Project  
 1010 Swan Valley Recreation and Wellness Centre  
 Phase One  
 Drawing  
 Roof Plan

Project  
 1010 Swan Valley Recreation and Wellness Centre  
 Phase One  
 Drawing  
 Section Details

Parapet Cap Construction:  
 Pre-finished cap flashing  
 continuous cleat each side  
 Roof membrane  
 13mm exterior grade plywood  
 38mm exterior grade wood shim  
 13mm exterior grade plywood  
 T.O. Parapet  
 109 500

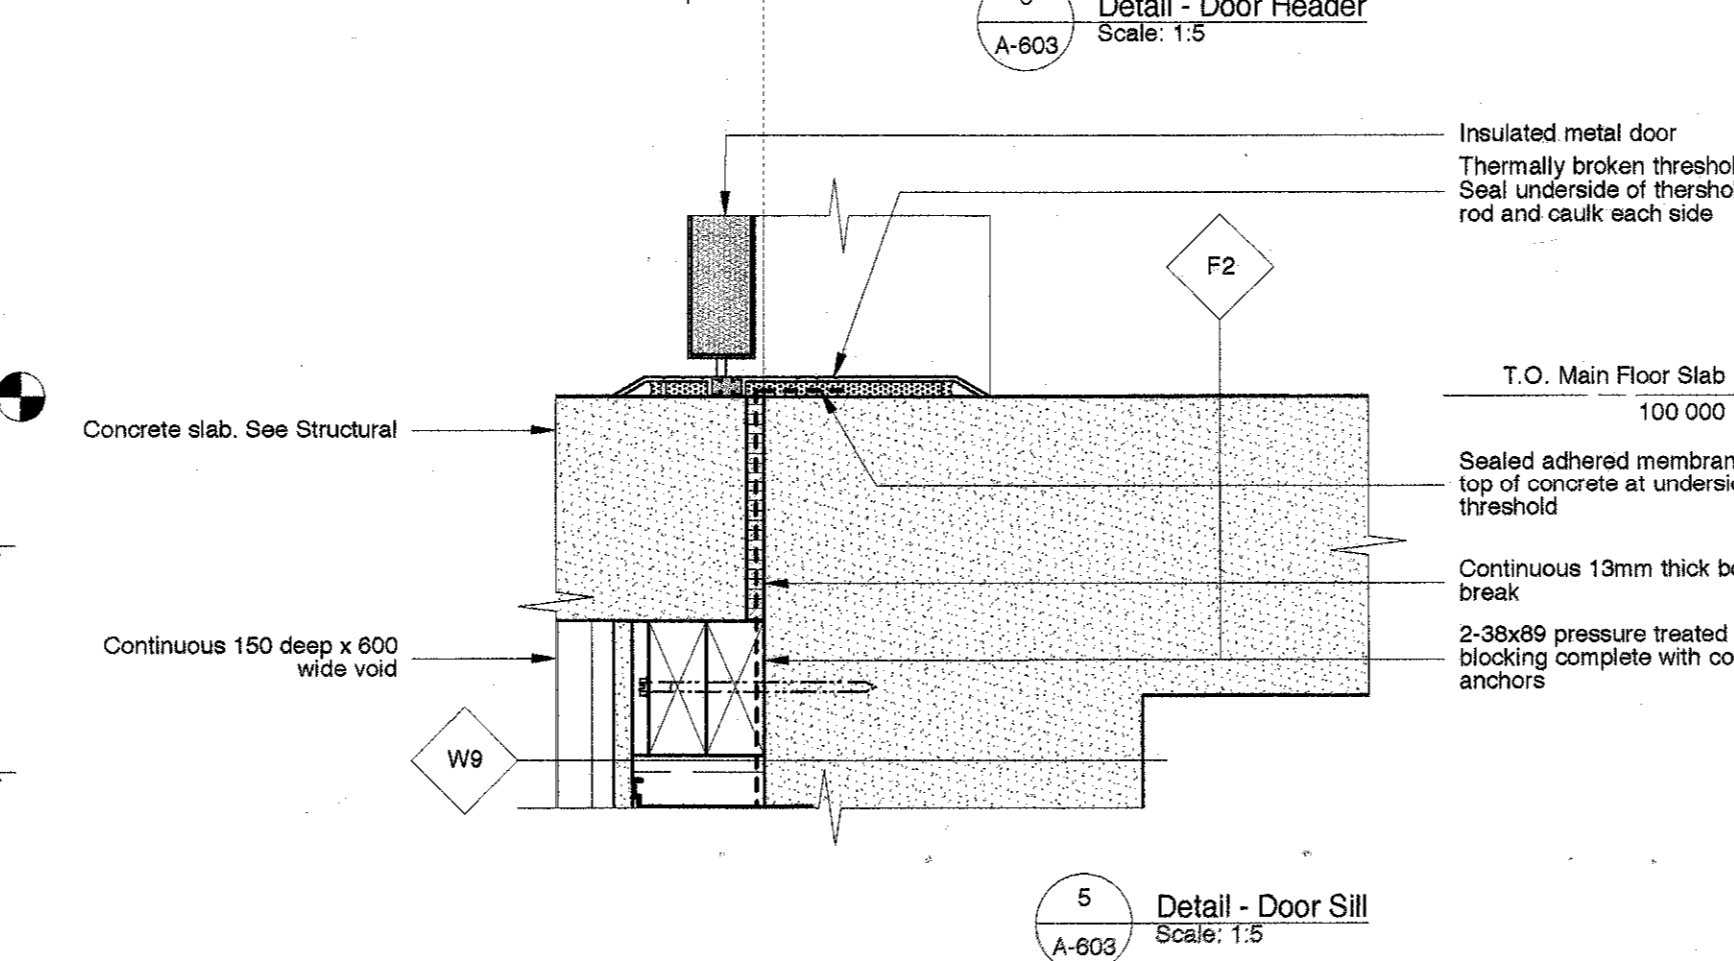
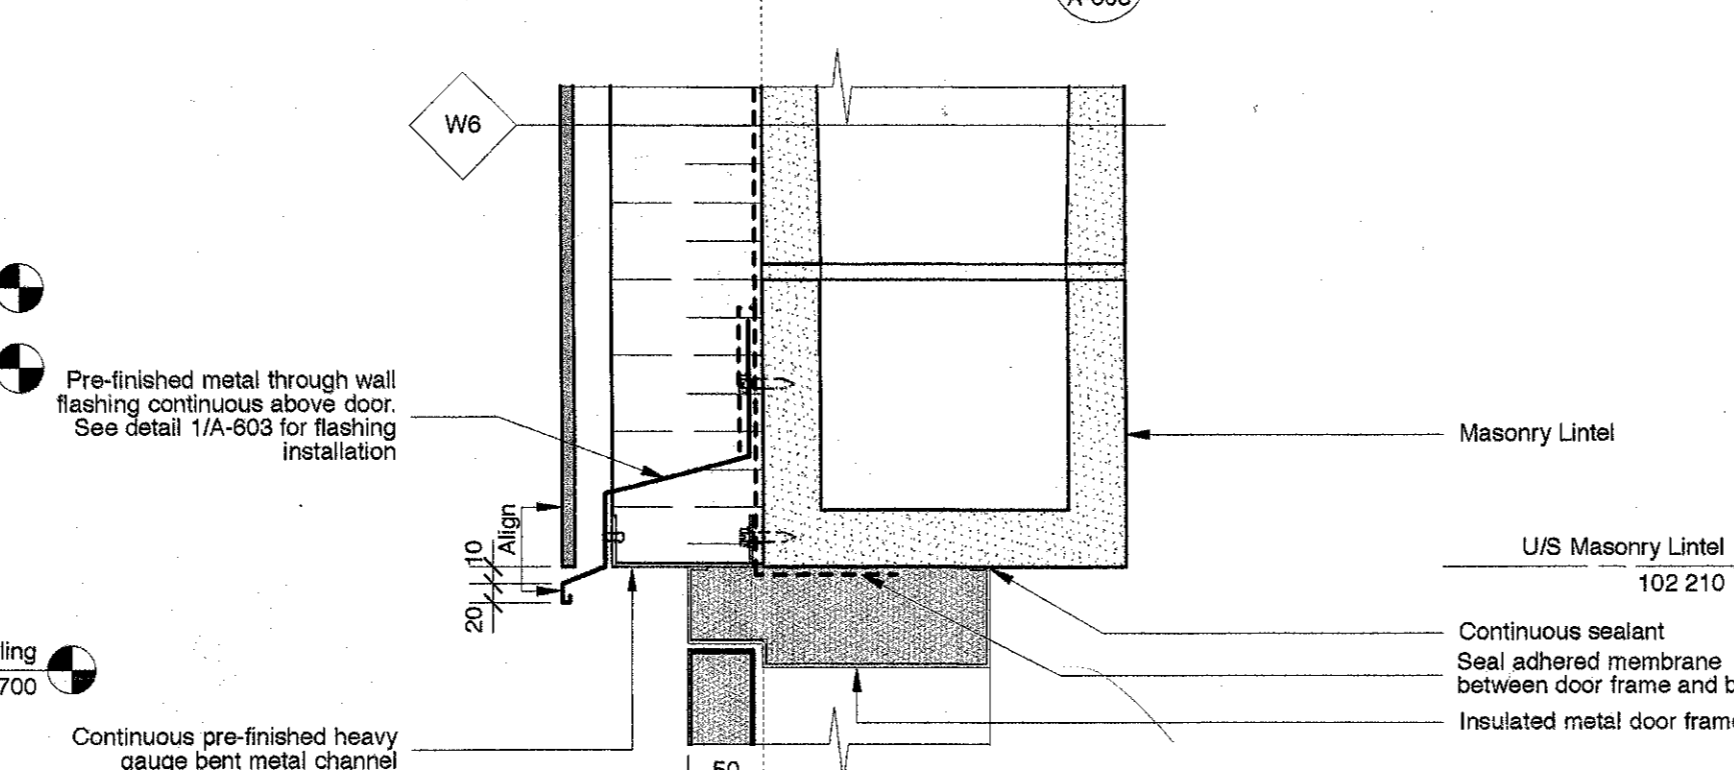
SEE SI#47  
 FOR REVISED PARAPET DETAILS

remove approximately 1ft x 1ft area of roof membrane and insulation, to expose roof deck and parapet plywood. Replace a patch after examination (typical in 4 locations) t
